National Highways Authority of India (Ministry of Road Transport and Highways, Govt. of India) परियोजना कार्यान्वयन इकाई पालमपुर Project Implementation Unit – Palampur

Sub: Diversion of 19.5896 ha Forest land for Rehabilitation and Up-Graddation to Two Lane with Paved shoulder configuration & Strengthening of Padhar to Bijni (Package-VA) from 180.00 to Km 202.815 (Design Length. 19.050 Km), of NH-20(New NH-154) of Pathankot- Mandi Section in the State of Himachal Pradesh under the jurisdiction of Mandi Forest Division Distt. Mandi, Himachal Pradesh (Online proposal no- FP/HP/Road/154466/2022)-Resubmission of case after attending the observations raised by Project Screening Committee held on 17/04/2023 thereof.

**Ref:** -Office Letter No.I/47162/202 dated: 23-06-2023.

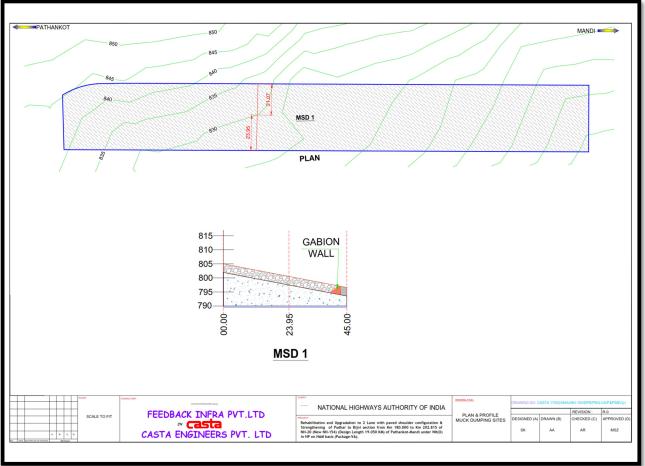
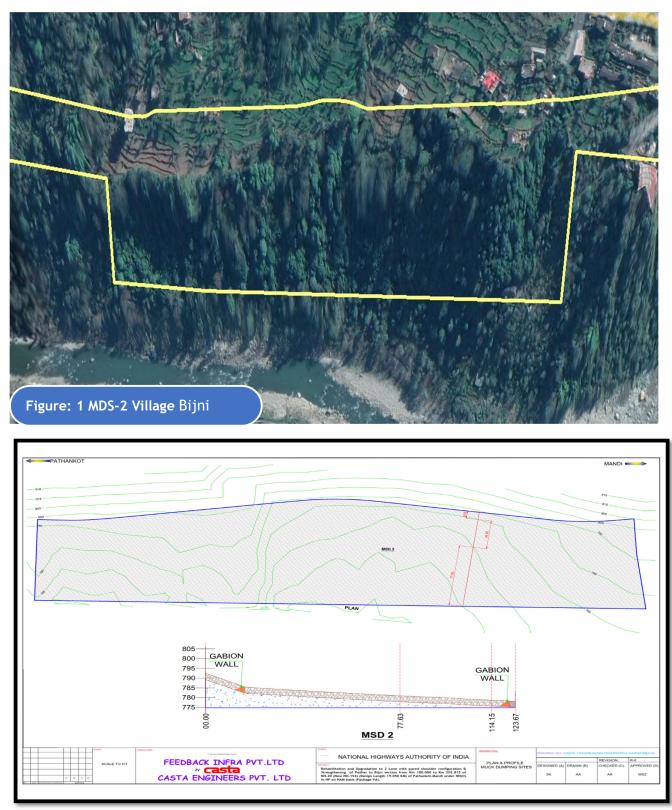
Sr.	Observation Raised	Reply of User Agency
No		
1	State Govt. may upload the Project Screening Committee minutes on the designated column of the PARIVESH portal	Authorities.
2	<ul> <li>i. It has been observed from KML file that the dumping site is in very steep slope from where debris can be easily rolled down into river/household and agriculture land downhill side. Therefore, the State Govt. may submit mitigation measures to be adopted, so that debris could not be rolled down into the river/household/agriculture land downhill side.</li> <li>ii. The Muck dumping site is proposed in forest land. The suitable non-forest land/private land may be explored for</li> </ul>	traverses through Mountainous & Steep Terrain. Thus, steep slope of

disposal of muck. Also, a separate list of trees standing in muck dumping site may be provided/uploaded if muck dumping is proposed in forest land. from iii. In revised muck disposal plan, total proposed area of muck dumping sites (Forest and Non-forest) is mentioned as 6.0750 ha, however in total calculation of the both dumping sites it is mentioned as 6.0180 ha. Also, it is submitted that "Out of the total 6.0180 ha, 4.2002 ha Forest land has already been diverted in 2021 through Proposal No-The FP/HP/Road/154466/2022 dated already 05.07.2022", however proposal mentioned(FP/HP/Road/154466/2022)

is submitted for FCA, 1980 approval. Therefore, State Govt. may review the muck management plan and clarify the contradictory statement mentioned in MMP. Environmental safeguard mitigation measures have been considered to prevent the debris from rolling down to river/household/agricultural land in downhill side.

These mitigation measures are proposed of gabion walls at different elevation levels to retain the muck as well as proposal of bio engineering techniques i.e. after completion of dumping, stone pitching and turfing with geo mats(Coir Textiles) etc will be done to stabilize the muck disposal site.

The detailed explanation has already been given in Muck Disposal Plan and same have been uploaded with the forest proposal. Kindly refer.

ii. As explained above, there are no other suitable sites available for muck disposal. Accordingly, these sites have been identified &selected for muck disposal and further duly checked and verified on ground by concerned Ranger & DFO during Joint site inspection on dated 16.12.2022.
